Product Change Notification

1. ECN #: 242181

- FMPS - FLEX MATE MINI POWER SOCKET ASSEMBLY

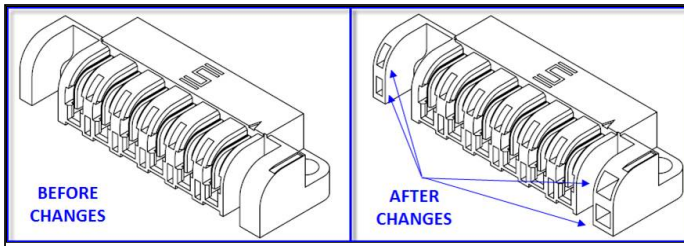
Added voids to improve end wall toe-in condition.

Old product does not have voids in the end walls. New product has obvious voids in the end walls.

Effort to improve historical end wall condition. Added voids allow more margin to prevent stubbing with mated half.

- Form - Added voids in end walls
